THOR-M Tilt Sensor Mounts

Publication Date: May 2016

Humanetics has improved the mounting accuracy of several tilt sensor mounts located within the THOR-M ATD.

Figure 1 - upgraded components

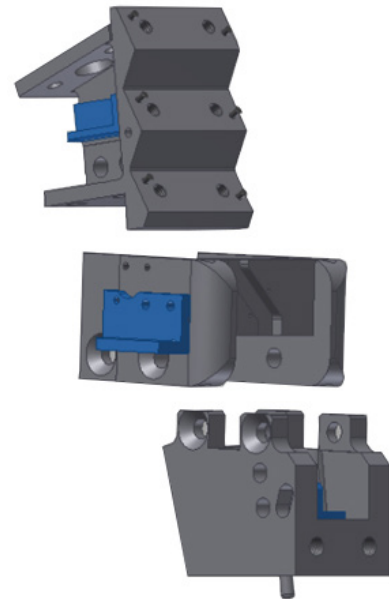
The differences in diameter of the bolt holes in the mounts and the actual bolts can allow up to 6 degrees of variance in the leveling of the mount on the base parts. This variance can affect the positioning of the tilt sensors and change the accuracy of the readings.

The mounts and the base parts have been updated to use locating dowel pins to decrease variance. The addition of dowel pins will position the mount more accurately with less than 0.25 degrees of tolerance, reducing the effect of the bolt holes in the leveling of the mounts.

Figure 1: 472-3650 Lower Thoracic Spine Box

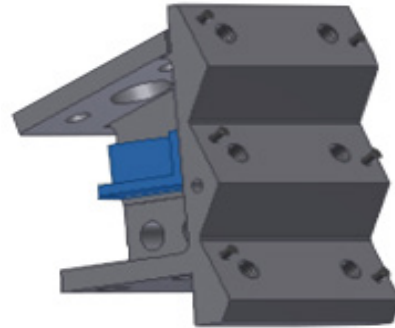
Existing lower thoracic spine boxes (figure 1) and pelvis and lumbar mounting blocks (figure 2) can be reworked to install the locating pin updates (example figure 4).

Figure 3: 472-3731 Thoracic Spine Adaptor Plate

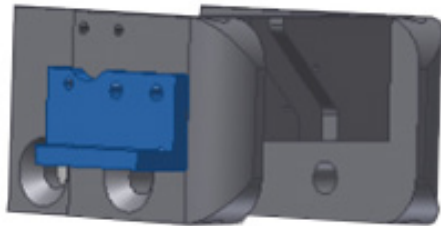
The thoracic spine adaptor plate (figure 3) cannot be updated and must be replaced to get the new mounting accuracy.
